RANCHO EL POTRERO

Revision of Tree Impact Report

Revised Report of Certified Arborist

Jeff Taylor Property
Carmel Valley, CA
Rancho El Potrero
A Proposed Subdivision

Figure No. 1

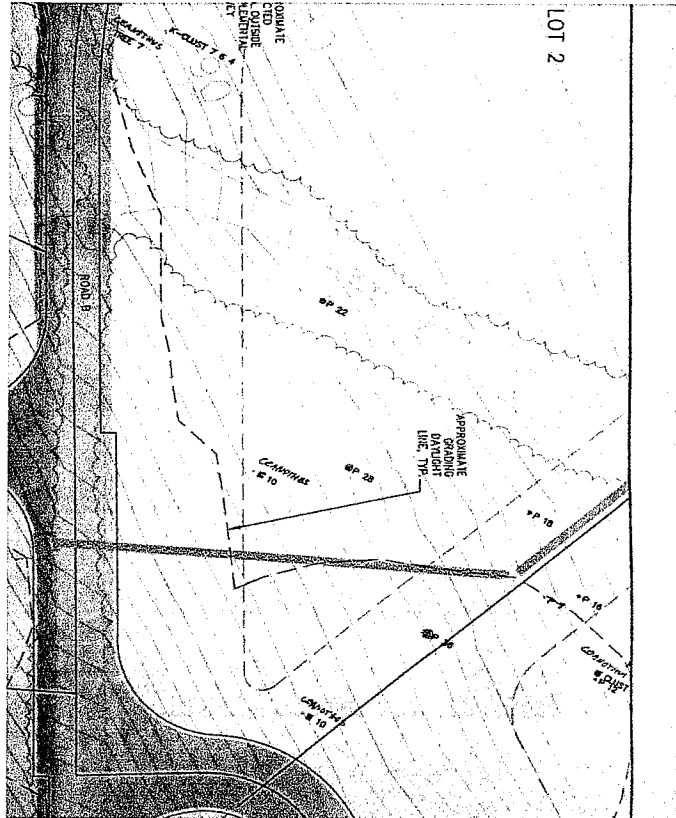
The observed identity of each specimen within the road grading area indicated on Sheet 1 is consistent with the tree designations as they are shown (see Figure No.1), with the following exceptions: Two trees designated as oaks, one a 10 inch dbh and the other a cluster, are Ceanothus. They are located in the grading area just north of the intersection of Road A and Road B as shown on Sheet 1. The photographs in Figures No. 2 and 3 illustrate these trees. (A third tree, likely a Ceanothus, located near the road spurs for Lots 2 and 3 and designated simply as "TREE 7" is missing). A fourth tree designated as an oak cluster of 7,6,4 dbh is a Ceanothus and is shown in Figure No. 4.

Partial reproduction of Sheet 1 showing corrected specimen designations for 3 *Ceanothus* trees within the grading zone.

Figure No. 2
(Tree No. 3277)

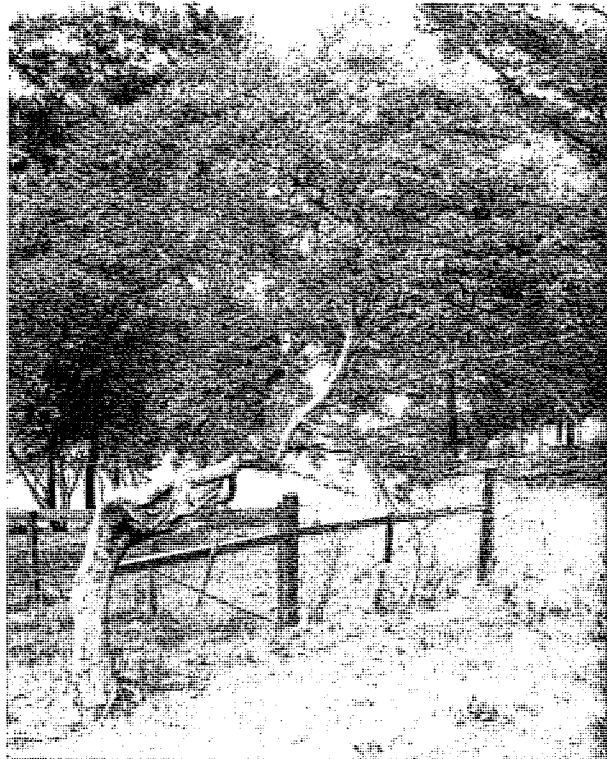
This and the following photograph illustrate the 2 *Ceanothus* which were misidentified within the grading area on Sheet 1

Figure No.5

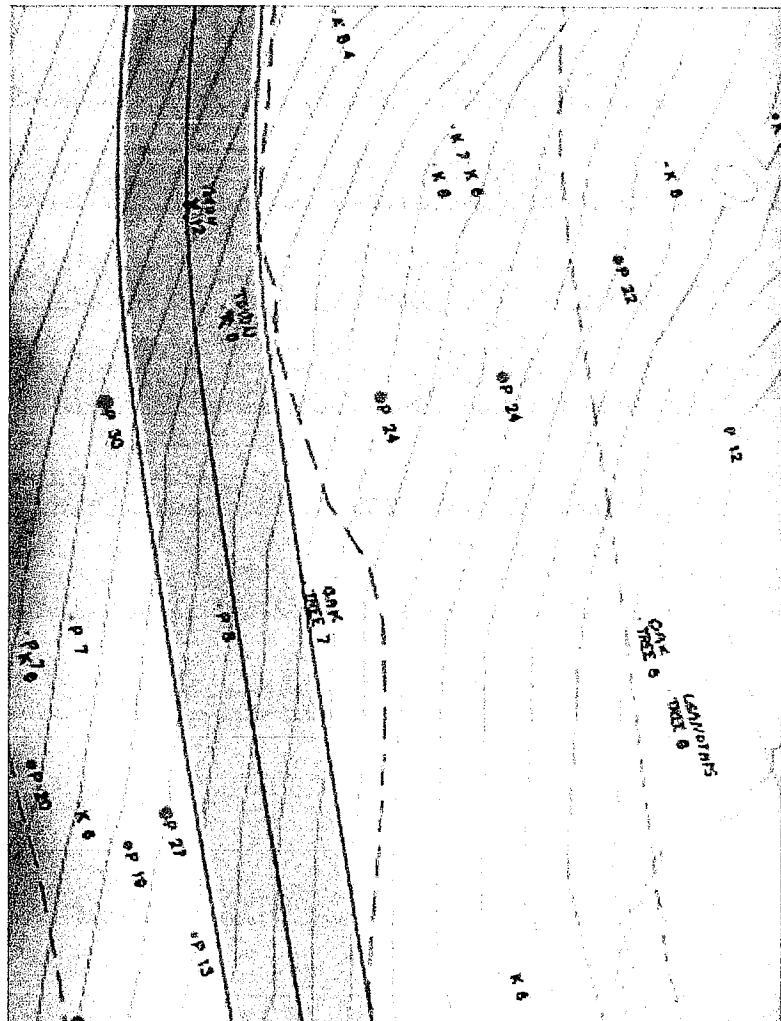
The observed identity of each specimen within the road grading area indicated on Sheet 2 is consistent with the tree designations as they are shown, with the following exceptions: Two of the trees designated as oaks, one a 12 inch dbh and the other a 6 inch dbh, are native Toyon. They are located at the apex of two currently standing angles of a wire fence which is not shown on the map. A third tree located within the grading area is designated simply as "TREE 7"; this is an oak tree and is located just at the north edge of the proposed road bed.

The partial reproduction of Sheet 2 shown in Figure No. 5 shows the location of these trees. The photographs in Figures No. 6, 7 and 8 illustrate these trees. (Note: the species designation for two trees outside the grading zone have also been corrected.)

Partial reproduction of Sheet 2 showing corrected specimen designations for 3 trees within the grading zone.

Figure No. 8
(Tree No. 3285)

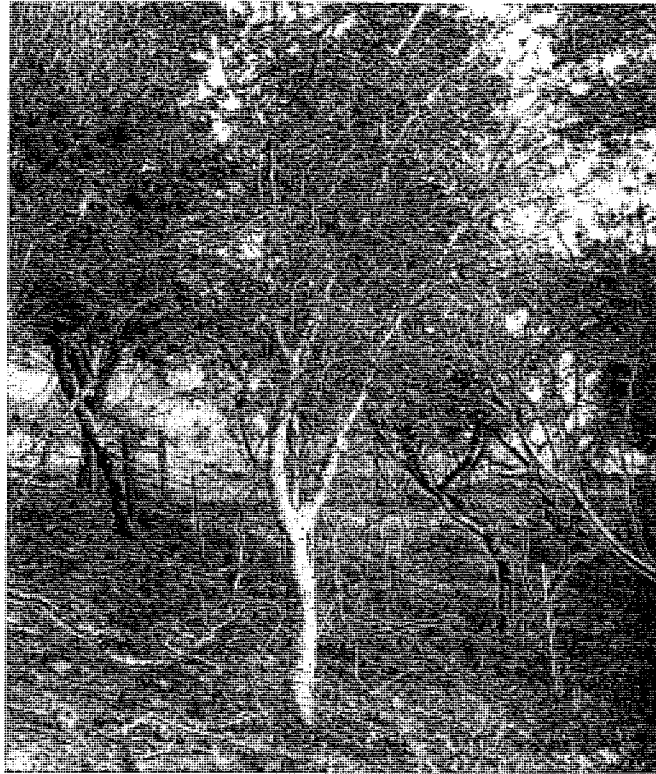
This and the following two
photographs illustrate the 12 inch
Toyon, the 6 inch Toyon (foreground
stem) and the 7 inch oak, in that order,
which were misidentified on Sheet 2

Oak, 7 inch dbh
